RASP MINE, BROKEN HILL 130 Eyre Street, Broken Hill PO Box 5073 BROKEN HILL. NSW 2880

**Subject: Rasp Project Preferred Project Report**

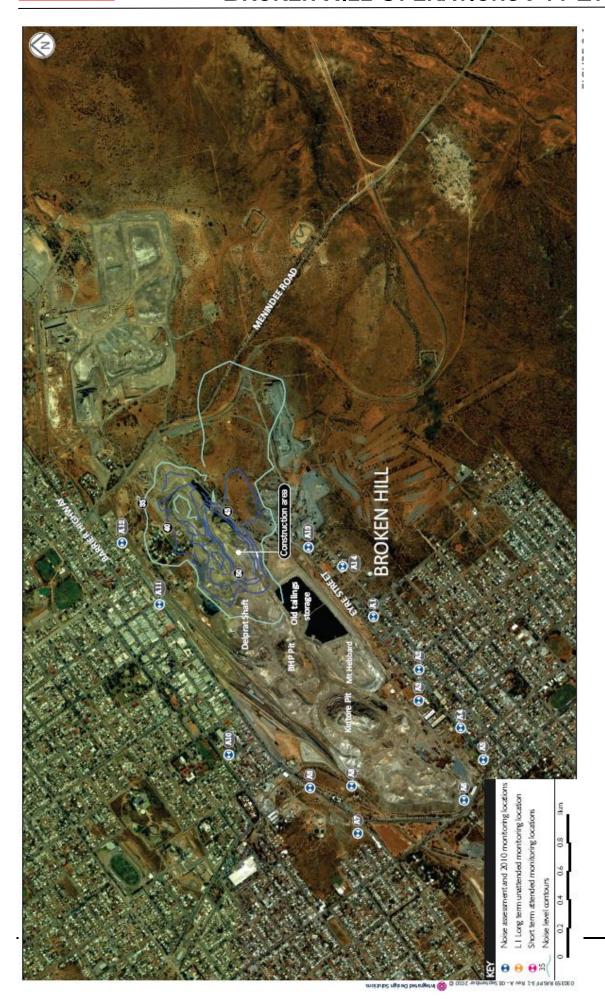
- Construction noise, in particular additional receptors (to A12) to be applied;
- Noise and vibration, as above dot point;
- Air quality, current receptors are concentrated in Eyre Street and Crystal Street and do not adequately monitor activity at the proposed operations area.
- Community health, comments as reflected in the GAWHS submission to the EAR remain the same, with an additional request that soil monitoring is made public – at least to the Lead Reference Group;
- Water resources, as per previous submission;
- · Rainwater tanks, as per previous submission, and
- Effluent reuse, as per previous submission.

The issue of construction noise limits and monitoring locations is moot given that predictions are well under the minimum threshold INP criteria of 35dB(A). It does not matter where or how many monitors are used during construction since levels are predicted to be relatively low and below background noise levels, refer below noise contours for construction.

Receptor A12 is a representative worst case assessment location used for defining potential levels in that area. When conducting any form of compliance monitoring, the community can be assured that the monitoring will be undertaken at the closest and most affected residence during the specific construction activity occurring at the time. If monitoring shows limits are met at the worst receptor, then they will be met at other less exposed locations.

Monitoring locations will be determined in agreement with DECCW and will form part of the Noise Management Plan.
